Nomad

ALERT SERVICE BULLETIN

WINGS — ELECTRICAL — AFT WING BREAK CONNECTOR — INCORPORATION OF MOD N875 (N22) & N876 (N24)

ANMD-57-13

Figure 1 Aft Wing Break Connector – Inspection

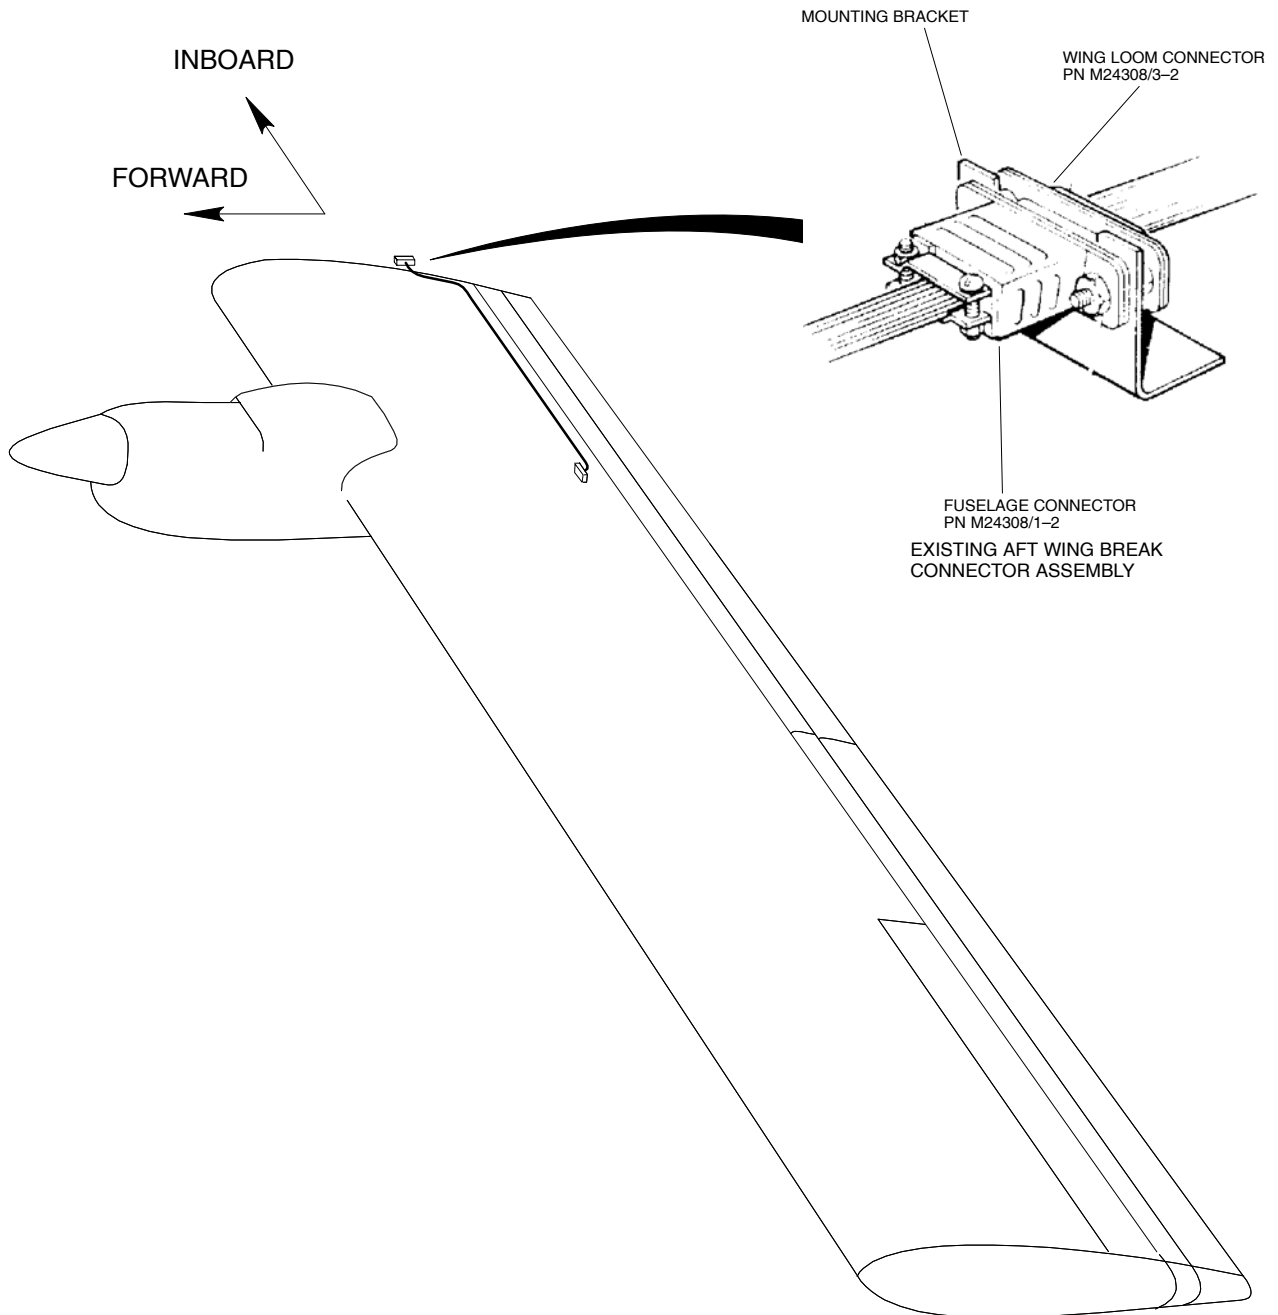
- (3) Disconnect the aft wing break connector (Ref Fig 1) and remove the fuselage connector from the mounting bracket.
- (4) Remove the strain relief back shells from each connector to enable inspection of both sides of the contact inserts.

- (5) If the connectors are contaminated, thoroughly clean both sides of the connector using a suitable cleaning solvent.
- (6) Inspect the connectors for arcing damage, deposits between contacts and looseness of contacts. If the connectors are found to be unserviceable, omit the following steps (7), (8), (9) and (10) and proceed to Part B.

Figure 2 Schematic of Connector Wiring – N22 (Mod N875)

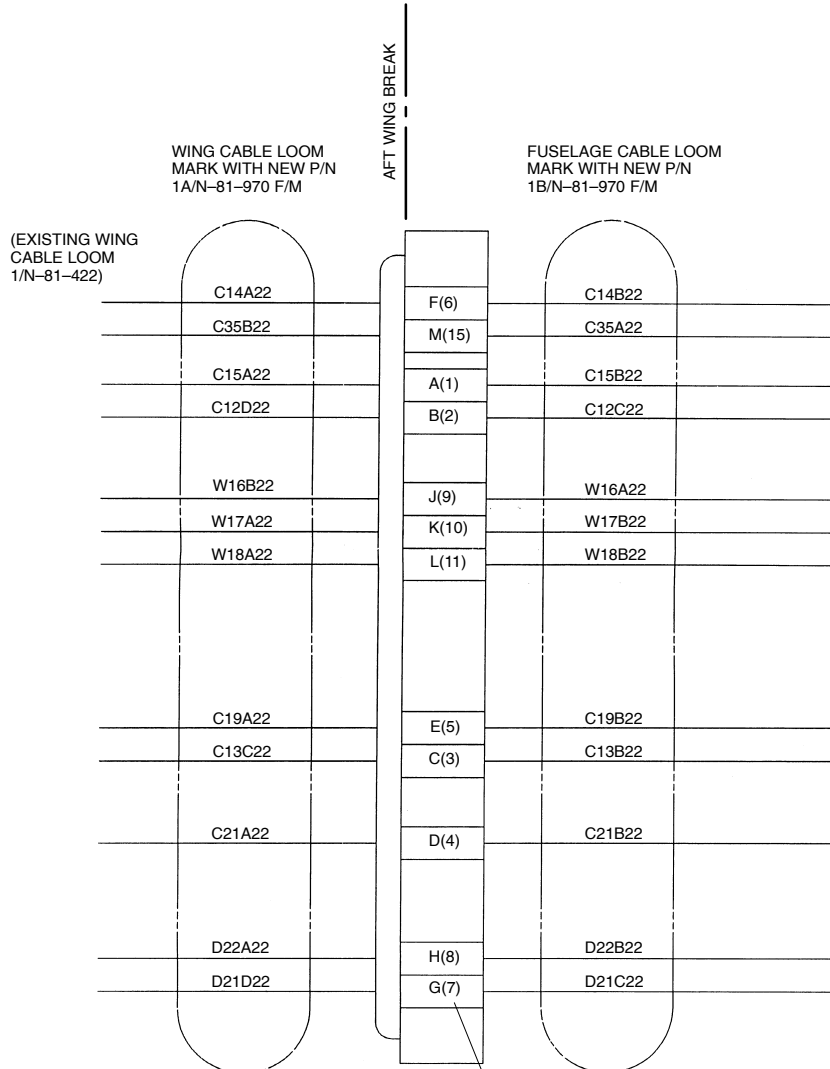
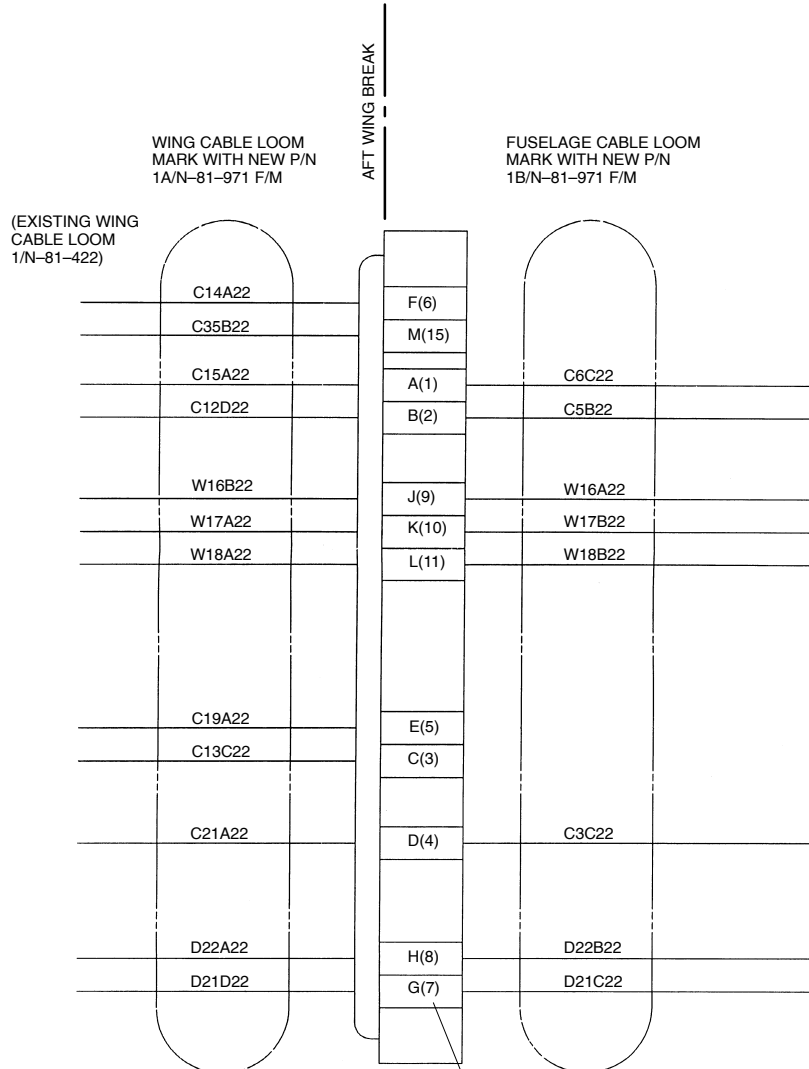
- (5) Prepare tail ends of wing cable wires, re-identify loom and connect to Connector Plug (MS3476L14-19P or alternative) in accordance with Figure 2 (N22) or Figure 3 (N24).

- (6) Prepare tail ends of fuselage cable wires, re-identify loom and connect to Connector Receptacle (MS3470L14-19S or alternative) in accordance with Figure 2 (N22) or Figure 3 (N24).

Figure 4 Revised Cable Connector Mounting

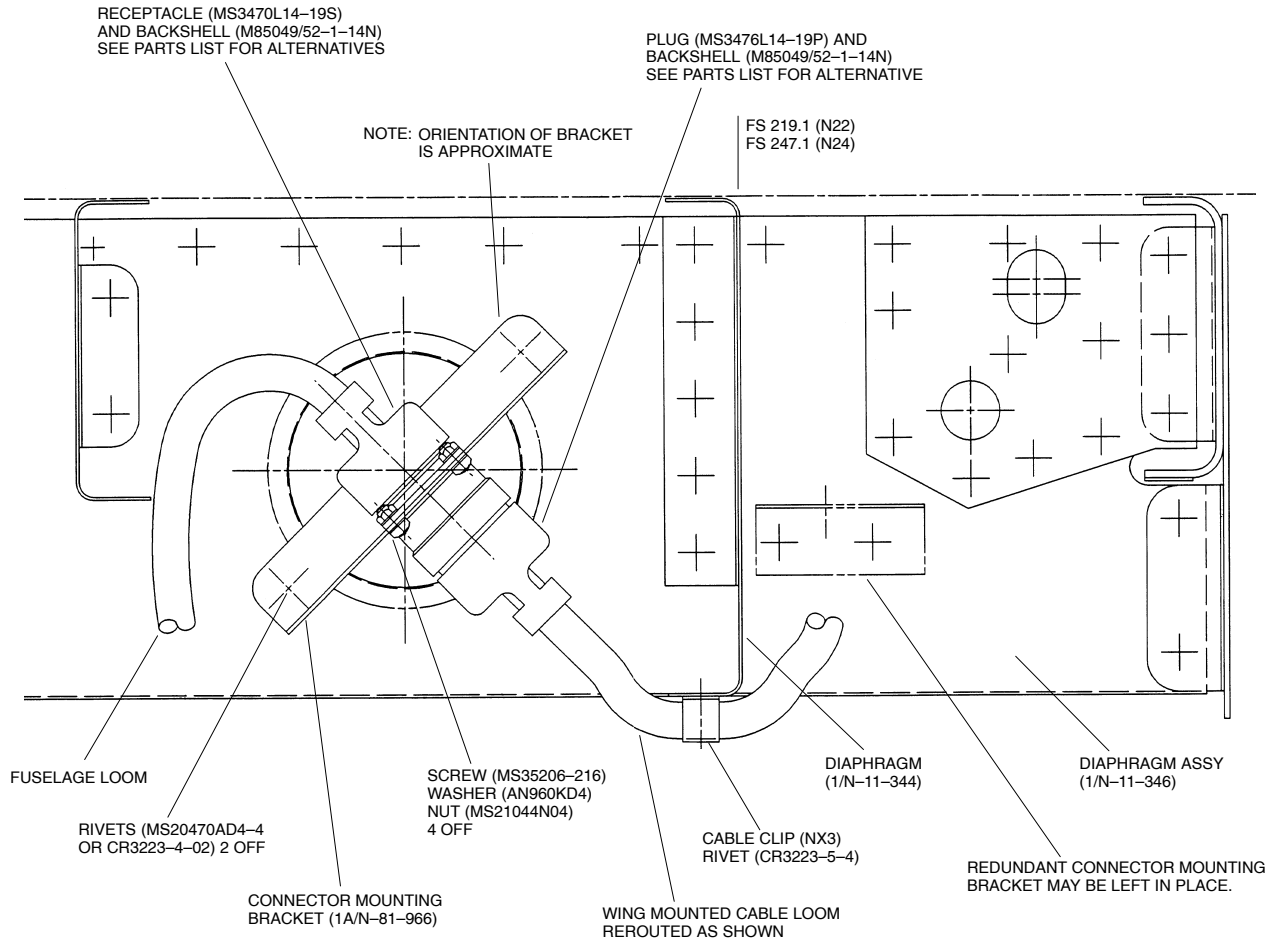
- (7) Attach new Connector Mounting Bracket (1A/N-81-966) as per Figure 4 with rivets (MS20470AD4-4).
- (8) Attach Receptacle to mounting bracket with screws (MS35206-216), washers (AN960KD4) and nuts (MS21044N04). Attach wing cable plug to fuselage Receptacle and secure.
